Geotechnical Comment Response
Moran Residence Development
5028 West Mercer Way
Mercer Island, Washington
NGA File No. 1211520

This letter documents our response to geotechnical city review comments regarding your planned residence at **5028 West Mercer Way on Mercer Island, Washington.**

| Moran Residence Development Cross Section A-A' Existing Seismic Slope Stability Analysis | |

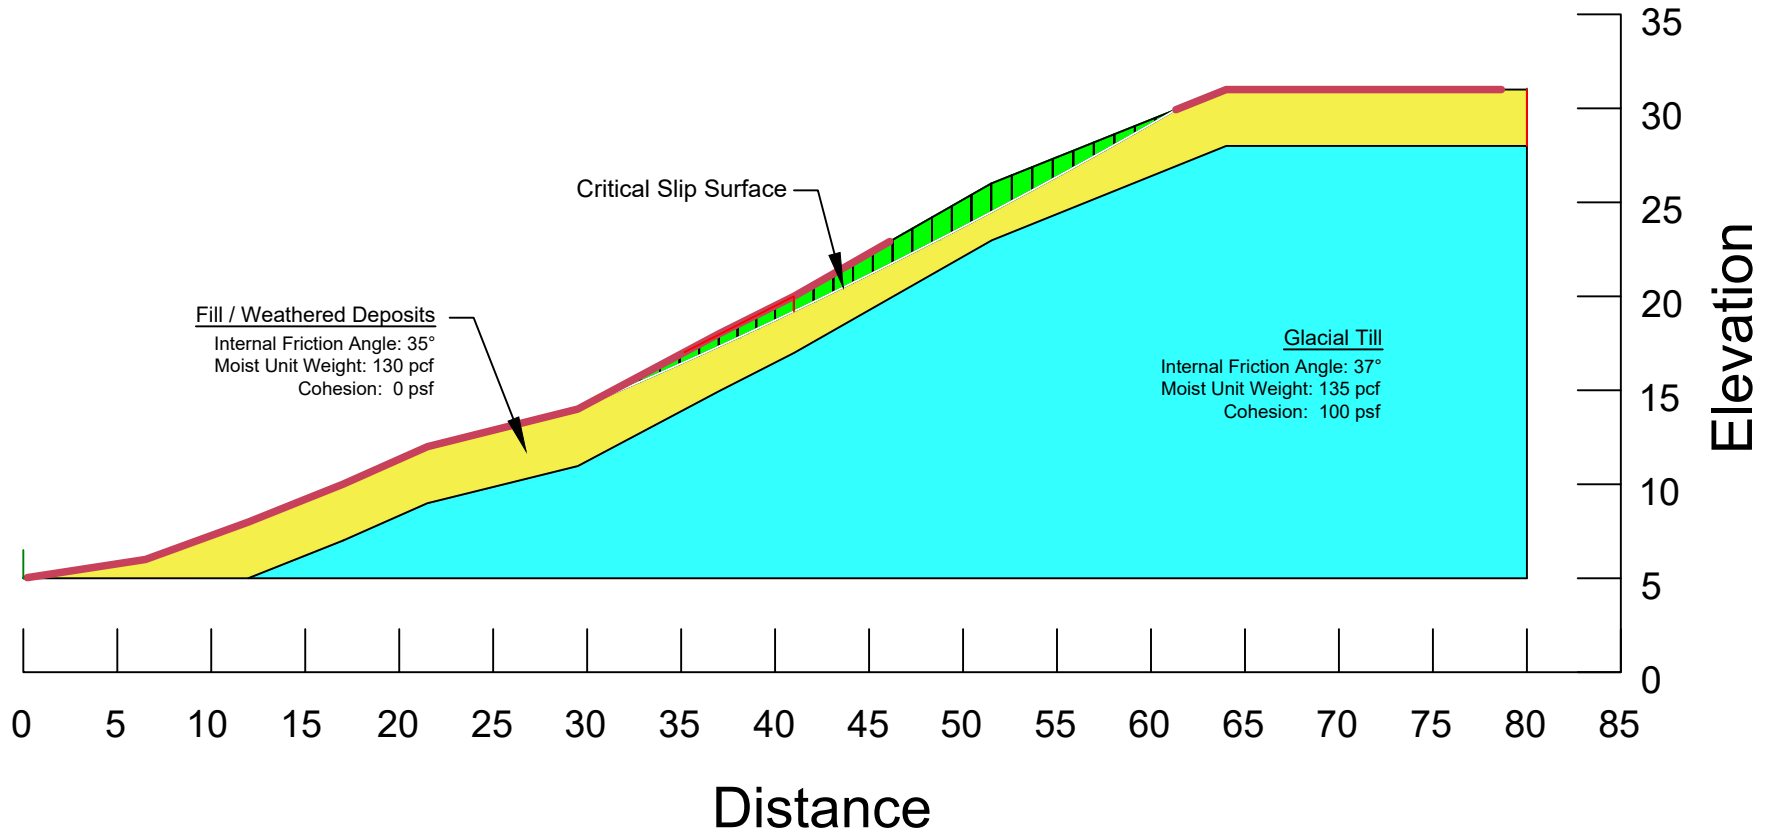
This comment is a follow-up to our previous response regarding the debris catchment measures recommended for this site. In summary, the comment requests additional information and justification regarding the debris runout analysis discussed in our previous response memorandum.

Slope Stability Analysis: We characterized the subject slopes landslide potential utilizing the computer software Slope/W, a limit-equilibrium slope stability analysis program. Cross-Section A-A' was generated utilizing the site's topographic survey along with information from King County IMap for offsite portions of the slope. Previous soil explorations along the eastern slope noted approximately 6-inches of topsoil underlain by weathered native glacial soils ranging from loose to medium dense. Based on evaluation and observation in the field the depth of loose material was typically 1.5- to 2.0-feet. Localized undocumented fill with variable density ranging from loose to medium dense was encountered up to 5-feet below the ground surface. The majority of the slope is well vegetated and does not appear to have historically been modified by clearing or grading, so we anticipate the 5-feet of fill is most likely localized and potentially associated with the residential property immediately above and to the northeast of the subject site. Nonetheless, we conservatively modeled the slope with a mantle of 3-feet of less competent material overlying the dense or better glacial material interpreted to form the core of the site slope. The material strength properties, parameters, and results of our slope stability analyses are shown in the Slope Stability Model on Figure 1. We evaluated the slope for most critical failure surface under static and seismic conditions, respectively. Per the ASCE 7 hazard assessment tool, the site's peak ground acceleration (PGA) is 0.619 with the geometric mean of the PGA (PGA_m) being defined as 0.681.

For the seismic scenario analysis, a pseudo-static horizontal acceleration parameter was applied to the slope, which was selected as 0.34g, using a standard ½ reduction to the PGA_m site-specific value. Under seismic load, the modeling indicates the most critical failure surface consists of a shallow skin slide failure with factor of safety of approximately 0.7. The behavior of the landslide modeled is consistent with our interpretation and assumed shallow translational type slide that may be expected on this site. Strong seismicity and/or long-duration rainfall would be scenarios where such a slide is more probable and could be expected to impact the upper loose and more permeable soils. Utilizing the same soil and seismic parameters, we also filtered through the various failure surfaces and selected a less likely (higher factor of safety) slide event just below a factor of safety of 1.0 to verify storage volume and proposed catchment capacity.
